Memo

Planning Application Ref: PL/25/0680

Proposal: New dwelling to the rear of No.5, replacing existing garage, including parking and landscaping

With reference the Arboricultural Report, 12th March 2025, Ref BPC 21366, I note the following:

Proposed site layout in arb report

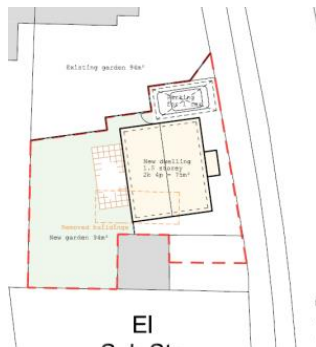
Section 2.1 uses an image of the site that is not consistent with the submitted plans. The report uses the image below, which is not that of The Proposed Block and Site Plans, April 2025, Dwg: 02-10. The north boundary, the angle of the dwelling and the car parking differ. The site layout plan used in the Report is below.

Design and Access Statement

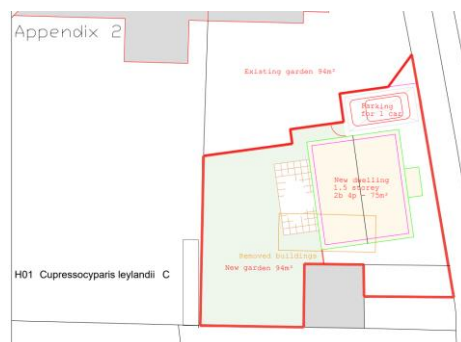
Section 3.2 states 'There are no on-site trees.' Section 3.5 states 'At the rear of the site there is an off site Leylandi hedge'. From comparing this to an arial photo of that in the Design and Access Statement, May 2025, Ref: CA-1082-DAS01, Rev 1. I note that there is more vegetation that surrounds the site boundary than that which is described, possibly including trees, that may be impacted as a result. The D&A Statement suggests 'The existing boundary planting is to be retained', however The Arboricultural Impact Assessment Plan, 16th March 2025, BPC – 21366, only recognises a section of the boundary hedge at the rear of the development area. Existing vegetation also appears to be shown in other areas of the Block Plan.

Block Plan

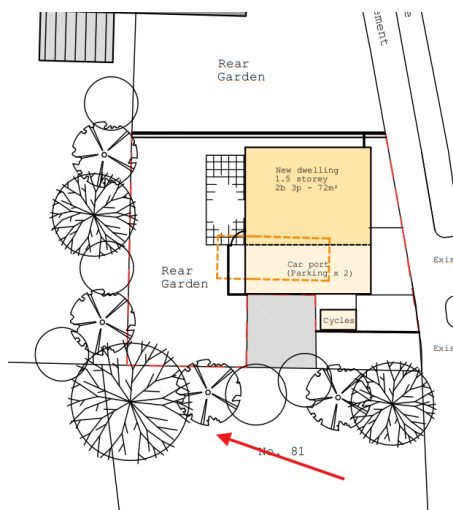
The AIA plan also does not include plotted RPAs. The reasoning for excluding RPAs within the report is not suggested.

DAS

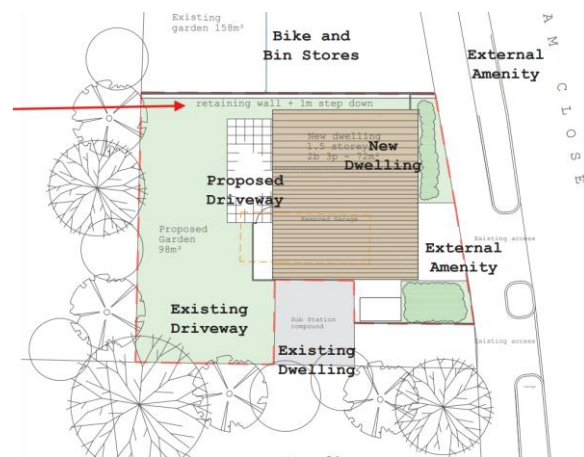
The DAS shows a retaining wall and 1m change in ground levels. The arb report doesn't recognise a change in ground level.

It appears that some of the vegetation on the frontage will be removed, along with the vegetation on the north boundary. New planting appears to be proposed on the frontage.
